## North Hill Communities Heritage Guideline Development Permit and Applications Overview

This document provides an overview of received applications within the Heritage Guideline Areas that were subject to discretionary review or comment from Heritage Planning and Community Planning with regard to heritage considerations.

Permit: DP2023-02251

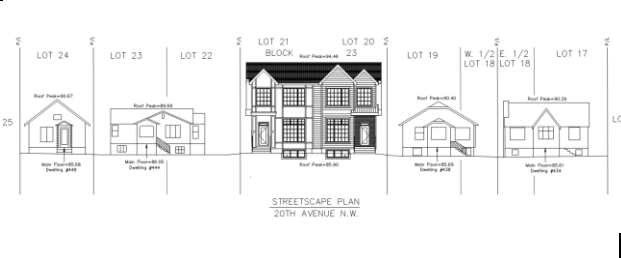
Notes: Application generally aligns with the design guidelines, including pitched roof and vertically-oriented windows. The front entrance is a “void” (recessed) rather than the required projection.

Permit: DP2023-02829 (backyard suite)

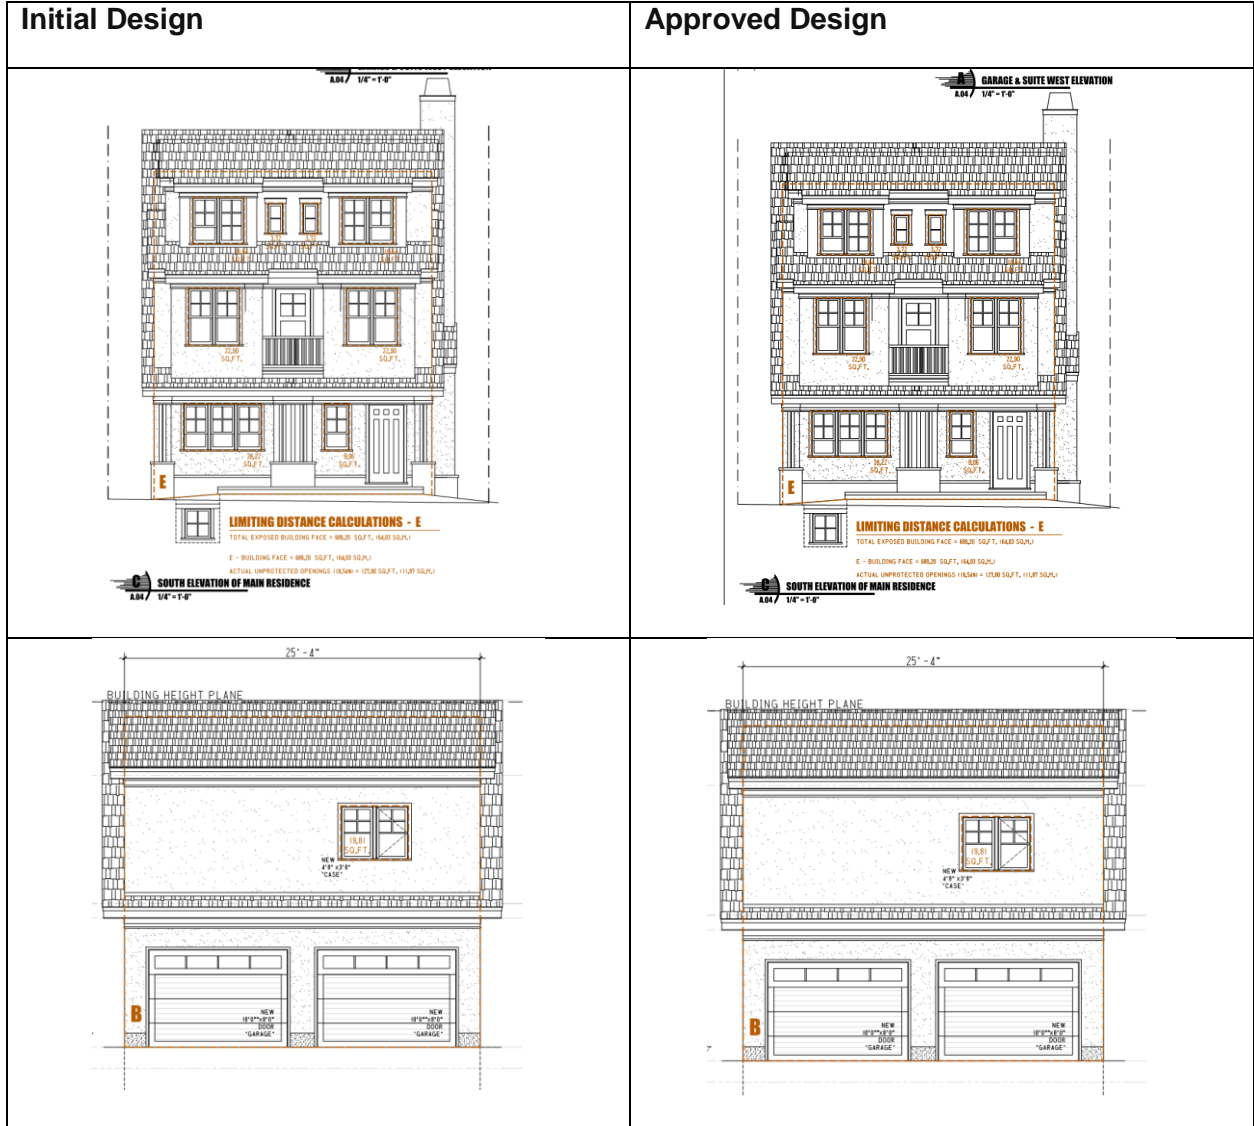
Notes: Application aligns with the design guidelines, including the roof pitch, window format and front-projection (covered porch).

Permit: DP2023-04120

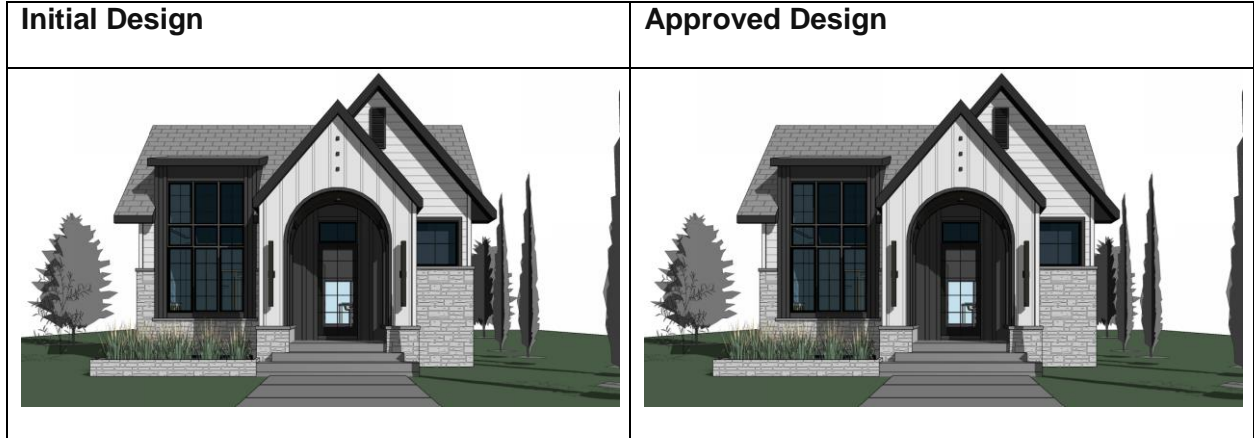
**Notes:** Application generally aligns with the design guidelines, including the roof pitch, window format and front-projection (covered entry). No block plan was provided to show context.

**Permit:** DP2023-04121(Backyard Suite)

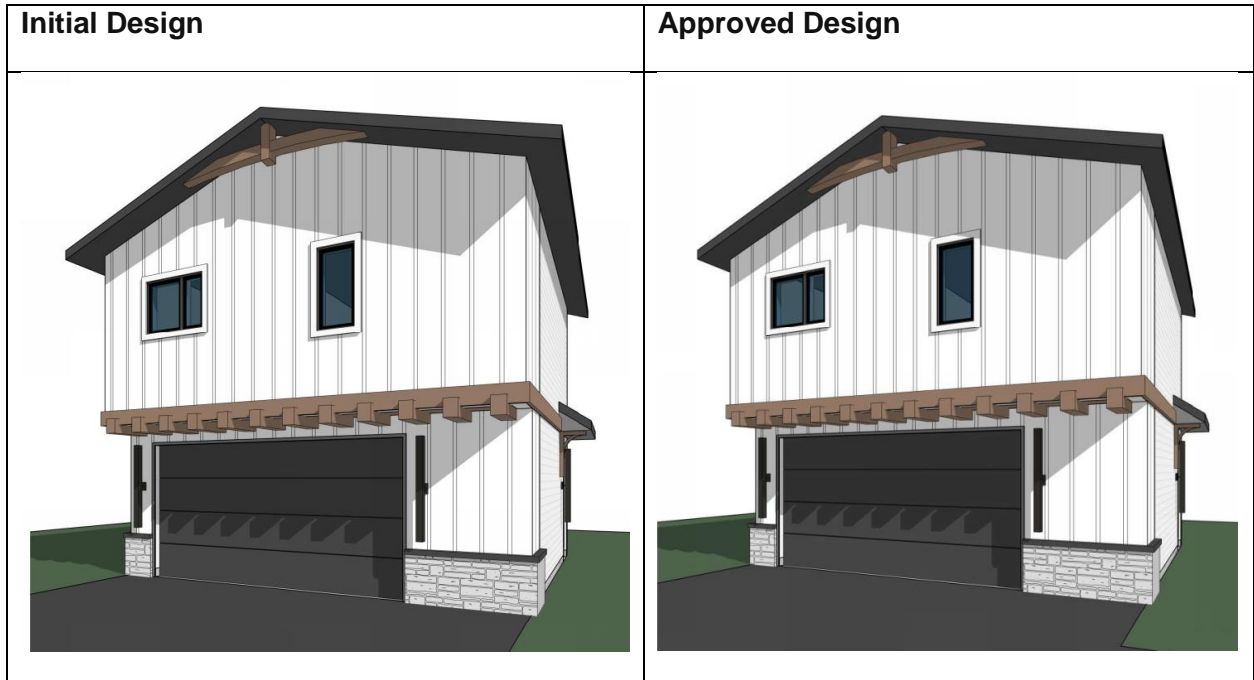
**Notes:** Backyard Suite associated with DP2023-04120 above.

Permit: DP2023-05063

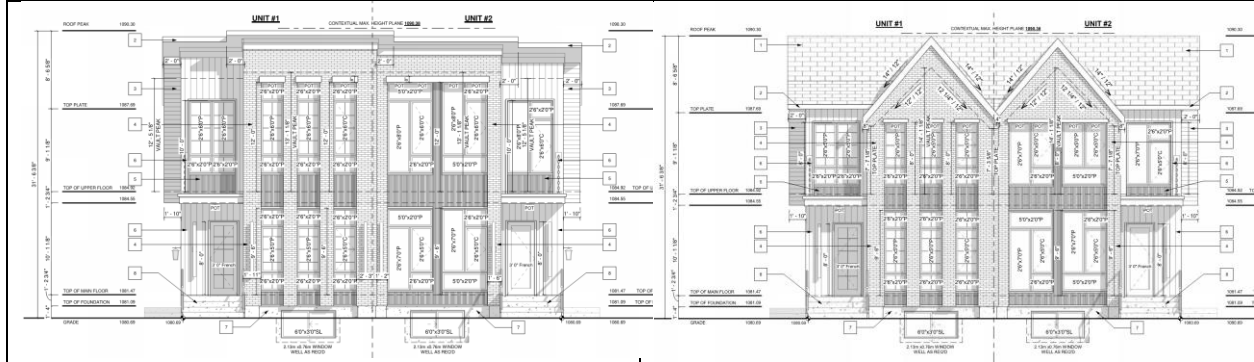
Notes: Application generally aligns with design guidelines, including pitched roof and vertically-oriented windows. The front entrance is a “void” (recessed) rather than the required projection.

**Permit:** DP2023-05564

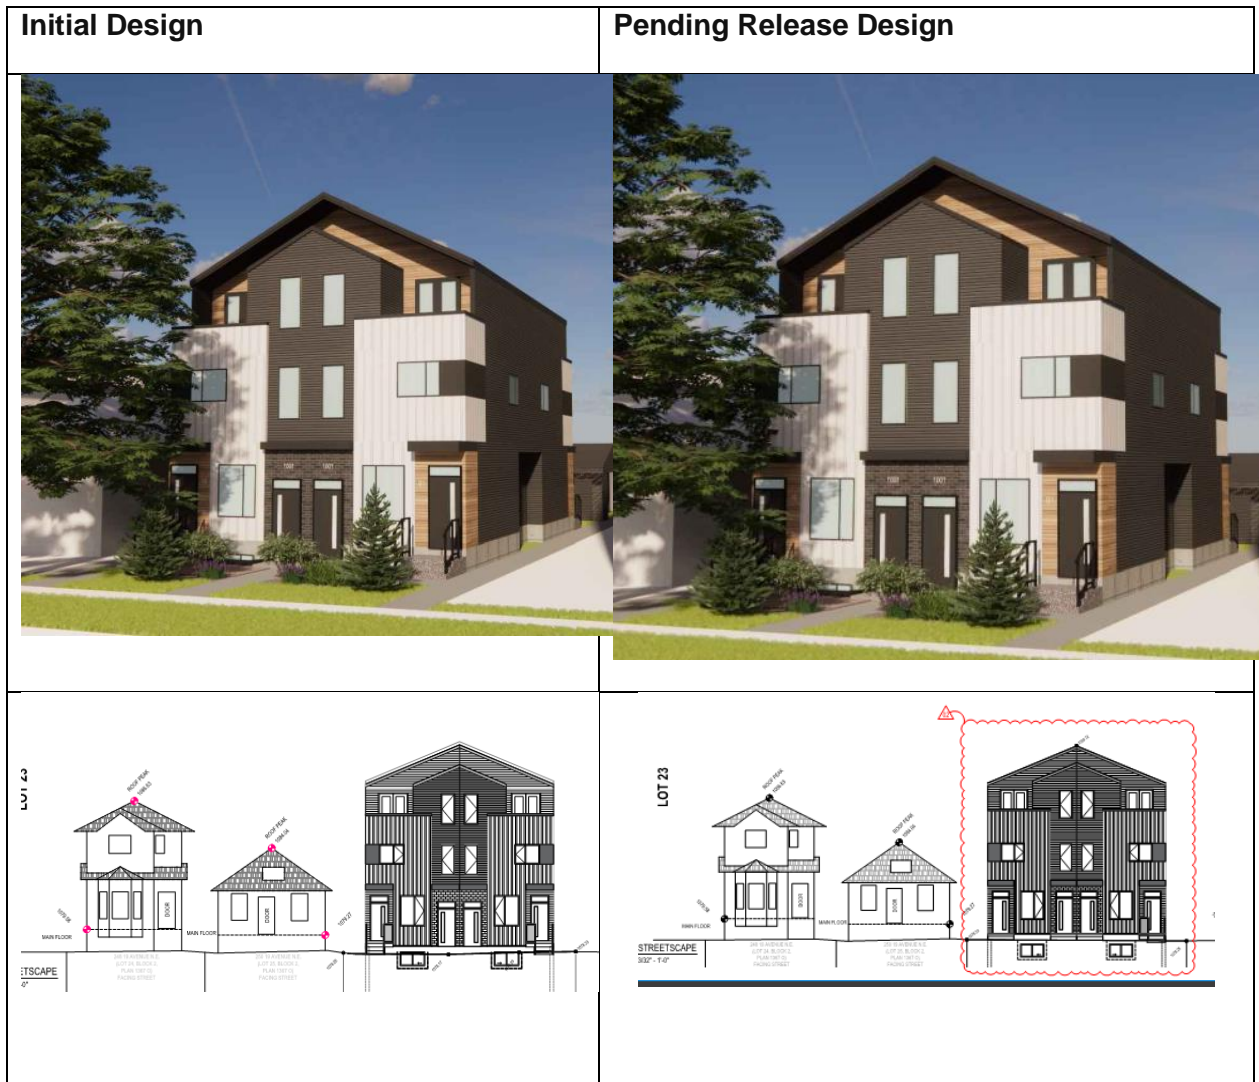
**Notes:** Generally does not align. The current design has some early alignment with the guidelines, such as the pitched roof, contextual setback and some vertical windows. There are opportunities for improvement in terms of the massing, materials and contextual fit with the historic landscape.

Permit: DP2023-08108

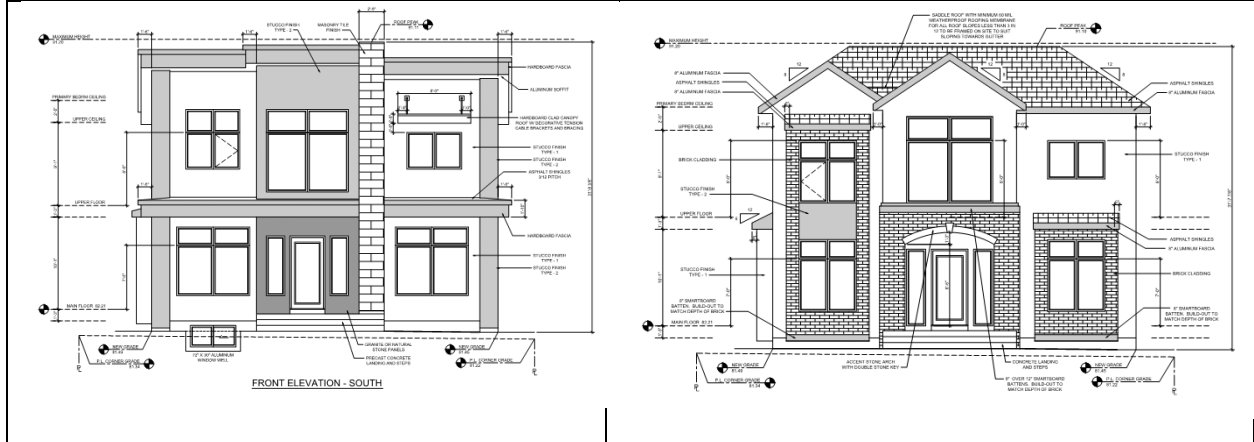
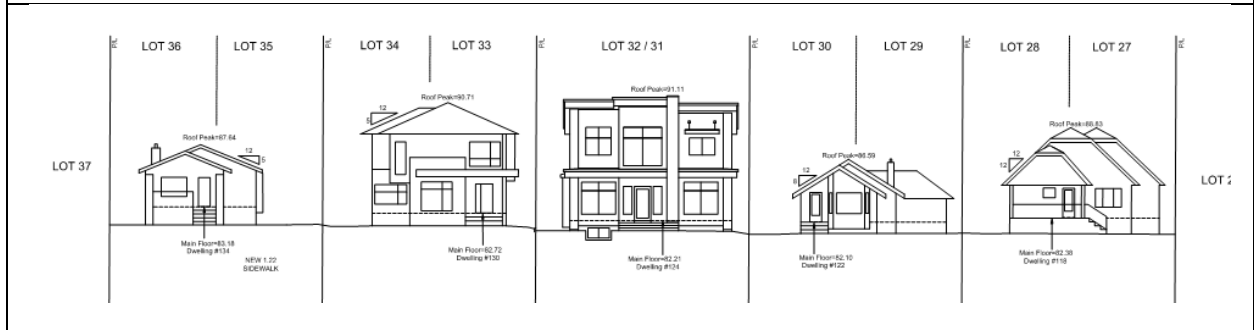
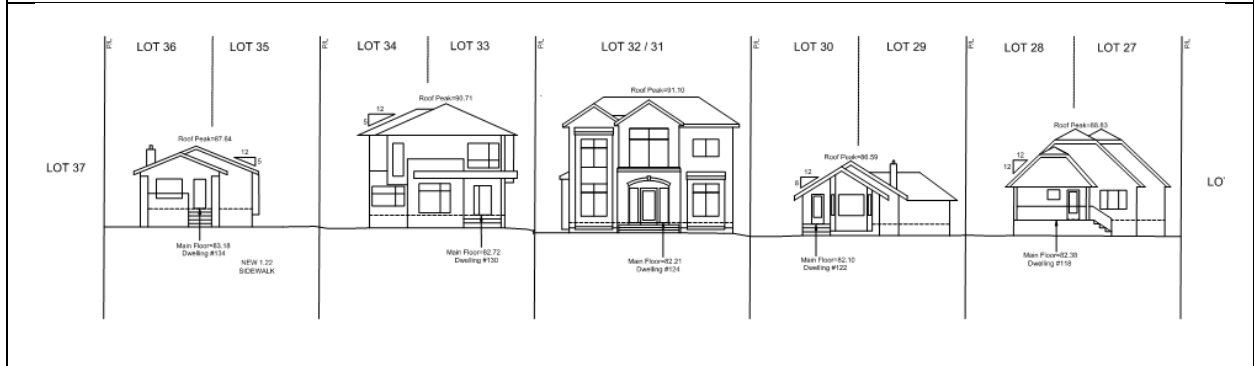
Notes: Advertis ed design shows a marked improvement in alignment with the design guidelines, including the pitched roof, material use and covered entry.

Permit: DP2023-08226

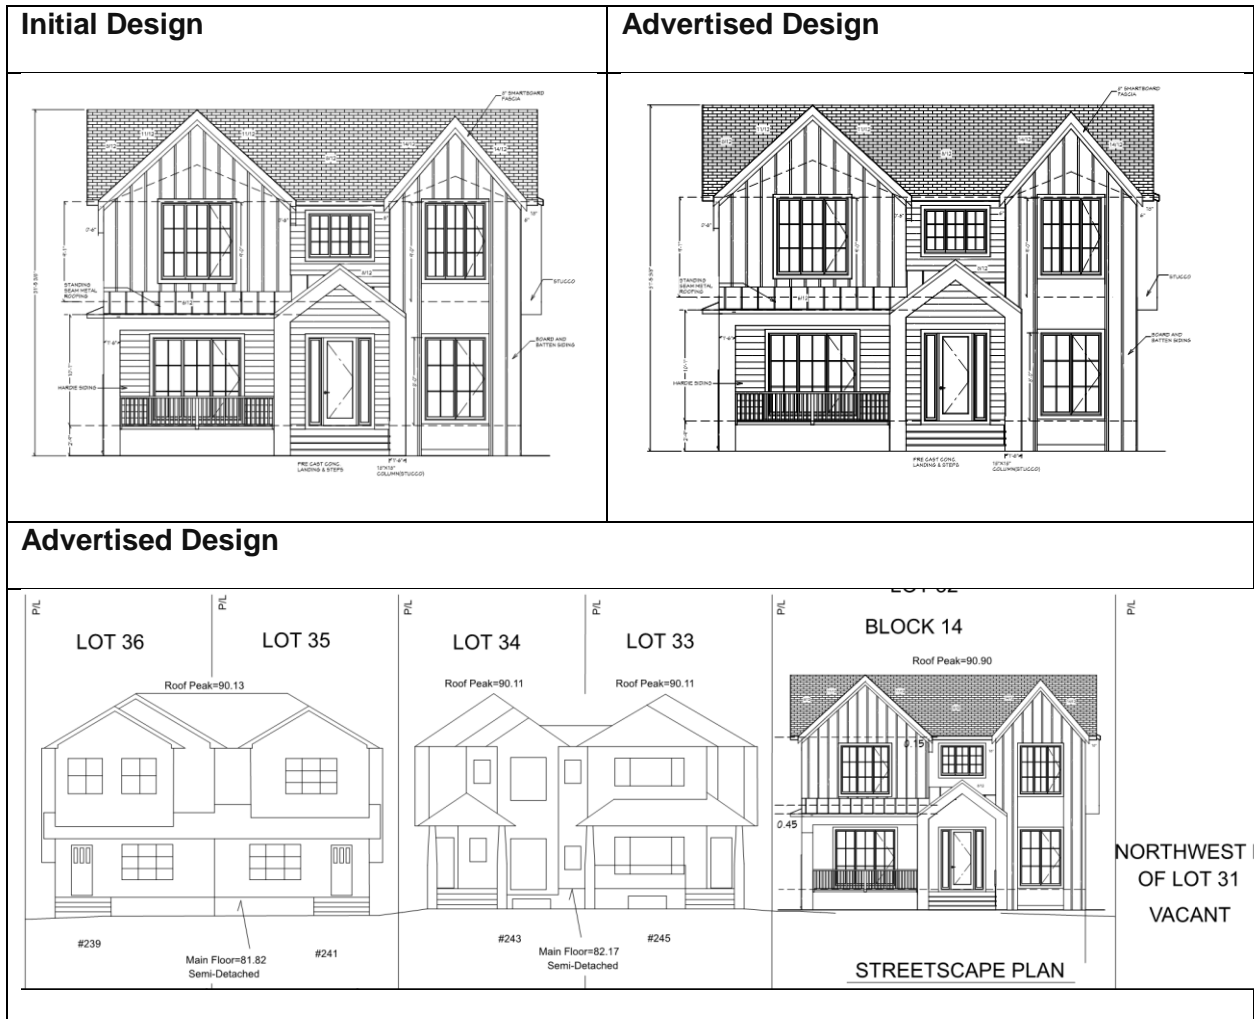
Notes: Initial and advertised design align with the guidelines and respond to the historic streetscape.

Permit: DP2023-08396

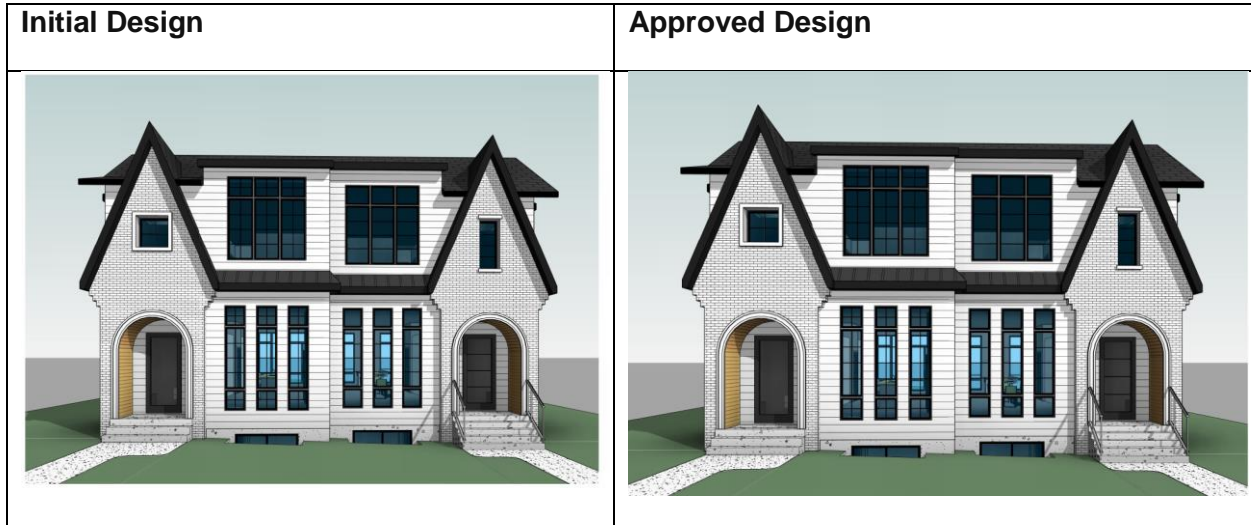
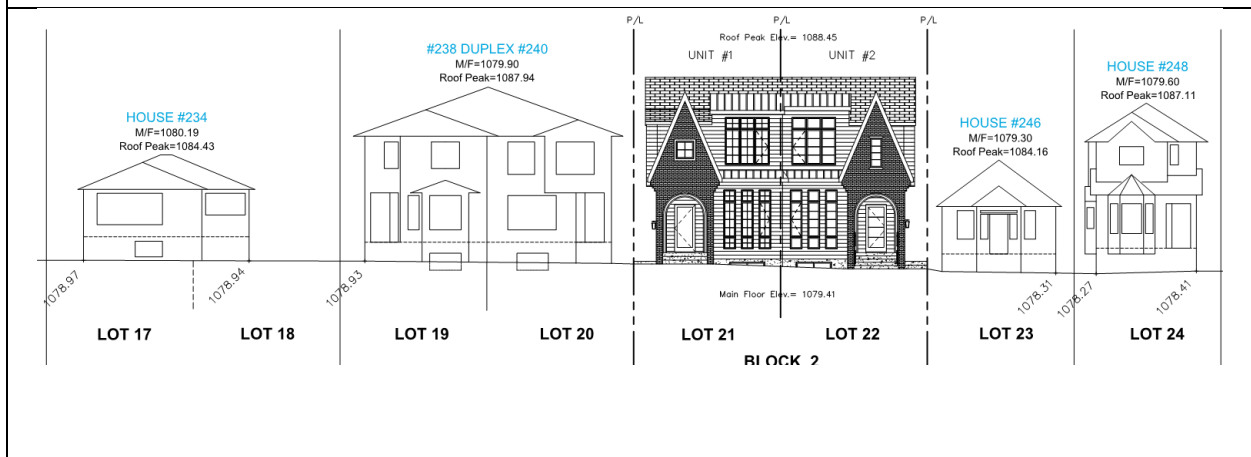
Notes: Initial and advertised design generally align with the guidelines and respond to historic streetscape.

Permit: DP2023-08731

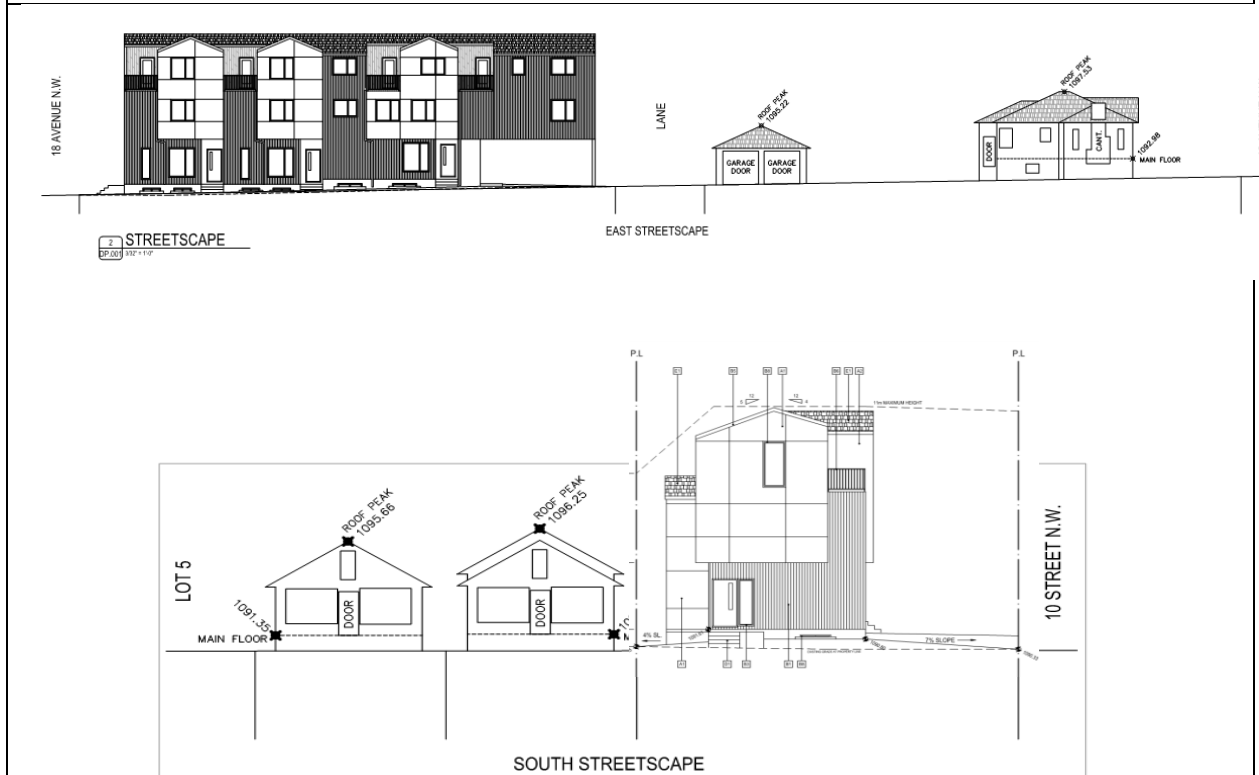
Notes: Revised plans have not been received. South elevation was not shown on South Streetscape plan, but is pictured below streetscape for reference. There are substantial deficiencies relative to the Guidelines, including building massing, materials, front projections, roof pitch, façade articulation and a response to the historic streetscape.

Permit: DP2023-08815

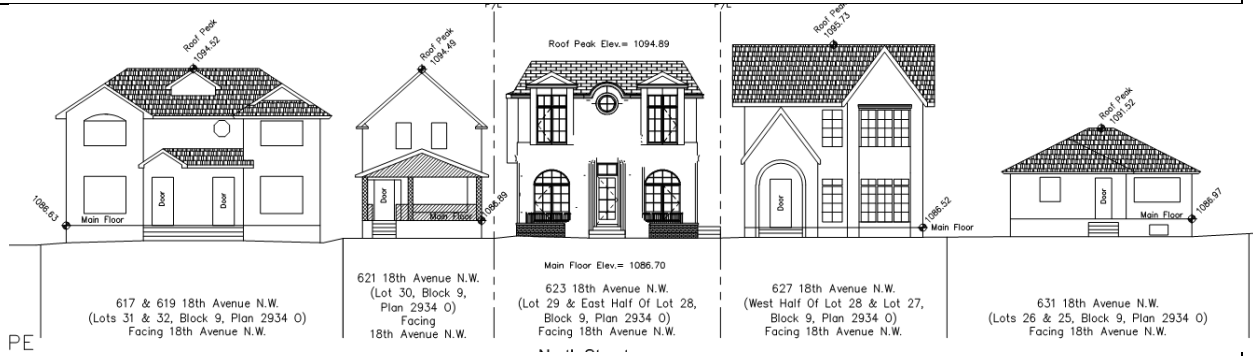
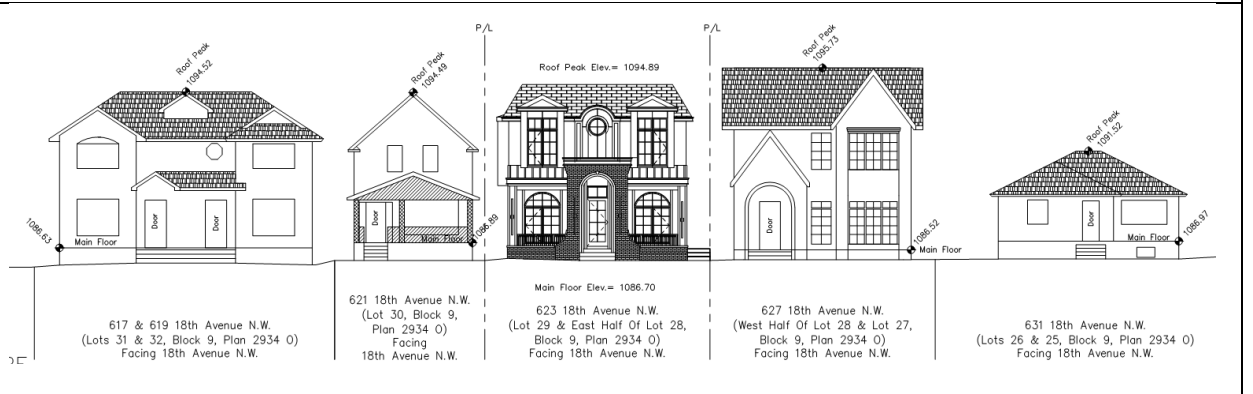
Notes: Coordinated with Heritage Planning to increase alignment with the Guidelines, including a covered front projection and material use, which enhanced the response to the historic streetscape.
